UNITED STATES PATENT AND TRADEMARK OFFICE

APPLICATION NO.	FILING DATE	FIRST NAMED INVENTOR	ATTORNEY DOCKET NO.	CONFIRMATION NO.
10/560,822	04/05/2006	Gerard Olivier	281470US2XPCT	8916
22850	7590	07/19/2010		
OBLON, SPIVAK, MCCLELLAND MAIER & NEUSTADT, L.L.P.			EXAMINER	
1940 DUKE STREET			KWON, ASHLEY M	
ALEXANDRIA, VA 22314			ART UNIT	PAPER NUMBER
			1795	
NOTIFICATION DATE	DELIVERY MODE			
07/19/2010	ELECTRONIC

Office Action Summary	Application No. 10/560,822	Applicant(s) OLIVIER ET AL.
	Examiner ASHLEY KWON	Art Unit 1795

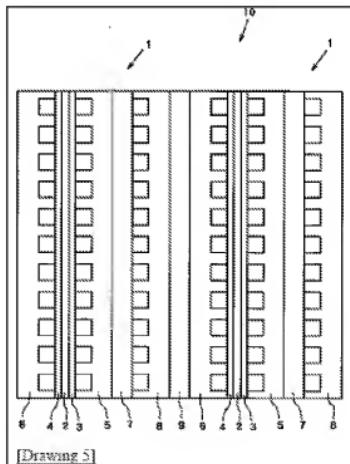
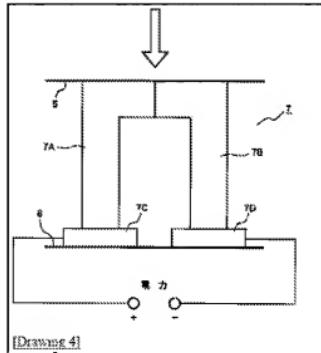
Regarding claim 10, Shirai discloses a fuel-cell stack (10), comprising: at least two adjacent elementary cells (1) capable of an exothermic combustion reaction constituting a heat source, the exothermic combustion reaction includes an oxidizer and a reactant, and the reactant and the oxidizer circulate within each elementary cell ([0008]-[0009]); an internal duct formed between the cells for circulation of a cooling fluid constituting a cold sink (field plate for cooling agent, 8); and a thermoelectric module (7, see drawing 4), each comprising a pair of elements of two conductive materials of dissimilar nature (p-type semi conductor 7A, n-type semiconductor 7B), a

first end of the pair being in thermal contact with one of the heat source (oxygen pole side field plate, 5) or the cold sink (field plate for cooling agent, 8), a second end of the pair being in contact with the other of the heat source or cold sink, and being electrically connected to a neighboring thermoelectric module (see drawing 5).

Regarding claim 11, Shirai in view of Yoshida disclose the fuel-cell stack according to claim 10, wherein the first end of the pair is connected with a conductive thermal contact to a bipolar plate of the heat source (*Shirai*: oxygen pole side field plate, 5), and the second end of the pair is in a thermal contact with the cold sink (*Shirai*: field plate for cooling agent, 8) (*Shirai*: see drawing 5).

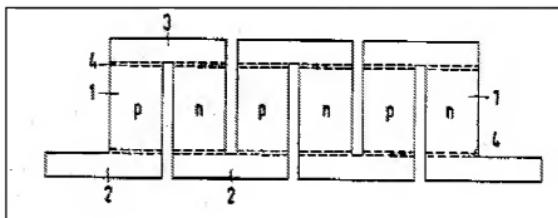
However, Ghamaty teaches thermoelectric elements, N and P-type samples consisting of silicon and germanium alloys, with the N-type doped with phosphorous and the P-type doped with boron (see col. 4, lines 18-20; col. 4, lines 40-41). Ghamaty teaches that a good thermoelectric material is measured by its "figure of merit", or Z , defined as: $Z = S^2 / \rho K$, where S is the Seebeck coefficient, ρ is the electrical resistivity, and K is the thermal conductivity. Good thermoelectric materials have large values of S and low values of ρ and K , which results in a high Z value as well (see col. 1, lines 15-30). The selection of a known material, which is based upon its suitability for the

intended use, is within the ambit of one of ordinary skill in the art. See *In re Leshin*, 125 USPQ 416 (CCPA 1960) (see MPEP § 2144.07). A person of ordinary skill in the art would have found it obvious to use N-type materials that are alloys of silicon and germanium doped with phosphorus and P-type materials that are alloys of silicon and germanium doped with boron since silicon germanium alloys are well known to have high Z values, in order to improve the thermoelectric materials (see col. 4, lines 49-50).

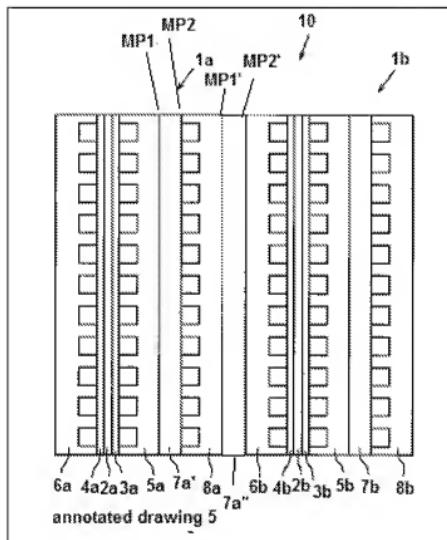
rejection, all of the plates labeled as metal plates 3 by Yoshida (*annotated drawing 5: MP1*) will be interpreted comprising said “first plate”.

However, Shirai teaches that although the embodiment described contains a thermoelectric element adjacent to the oxygen pole side field plate, the thermoelectric element could also be placed on the opposite side adjacent to the fuel electrode side field plate. Heat generated with the oxygen electrode transmits to the fuel electrode so there is a rise in heat on the fuel electrode side as well ([0029]). Thus Shirai teaches that the thermoelectric element, which transforms thermal energy into electrical energy, can be combined with either the oxygen pole side field plate or the fuel electrode side field plate ([0035]). A rationale to support a conclusion that a claim would have been obvious is that all the claimed elements were known in the prior art and one skilled in the art could have combined the elements as claimed by known methods with no change in their respective functions, and the combination would have yielded nothing more than predictable results to one of ordinary skill in the art. See *KSR International Co. v. Teleflex Inc.*, 550 U.S. ___, 82 USPQ2d 1385, 1395 (2007) (see MPEP §§ 2143 and 2143.02). Therefore it would have been obvious to one of ordinary skill in the art that a thermoelectric element could be placed on **both** the oxygen pole side field plate and the fuel electrode side field plate since it is known in the prior art for a thermoelectric element to be placed on either side. One skilled in the art would realize that by placing the thermoelectric element on both sides one would be able to more efficiently convert the heat generated by the fuel cell into electrical energy since heat is gathered from the fuel and oxygen electrode sides. See annotated drawing 5 above.

Furthermore, Shirai teaches that when a fuel cell stacks consists of three or more fuel cells, a thermal break (9) is preferred between each generating cell. However, Examiner would like to point out that a preferred embodiment is not the only embodiment possible. One of ordinary skill in the art would realize that if a thermoelectric element is placed on **both** the oxygen pole side field plate and the fuel electrode side field plate, the thermal break (9) is unnecessary since one would want to gather heat from adjacent fuel cells in order to increase the temperature difference at opposite ends of the thermoelectric element (see annotated drawing 5).

Annotated drawing 5 above depicts a second plate (MP2) configured to transfer heat; a second thermoelectric module layer (7a') configured to produce a third electrical power and the second thermoelectric module layer is disposed between and attached to the second plate (MP2) and the second fuel-cell (1a); and an internal duct passageway (8a) configured to circulate cooling fluid and to bring the cooling fluid in contact with both the first plate (MP1') and the second plate (MP2), and the internal duct passageway is disposed between the first plate and the second plate.

Regarding claim 22, Shirai in view of Yoshida discloses the fuel-cell stack according to claim 21, wherein the first thermoelectric module layer (7a") comprises a pair of dissimilar conductive materials (p and n type semiconductors) and each of the dissimilar materials include a heat conductor end configured to be in a conductive thermal contact with the second anode surface (6b) and to conduct heat away from the second anode surface, and a heat dispenser end configured to be connected to the first plate (MP1') and to dispense heat to the first plate.

Regarding claim 25, Shirai in view of Yoshida discloses the fuel-cell stack according to claim 21, wherein the second thermoelectric module layer (7a') comprises a pair of dissimilar conductive materials (p and n type semiconductors) and each of the dissimilar materials include a heat conductor end configured to be in a conductive thermal contact with the first cathode surface (5a) and to conduct heat away from the first cathode surface, and a heat dispenser end configured to be connected to the second plate (MP2) and to dispense heat to the second plate.
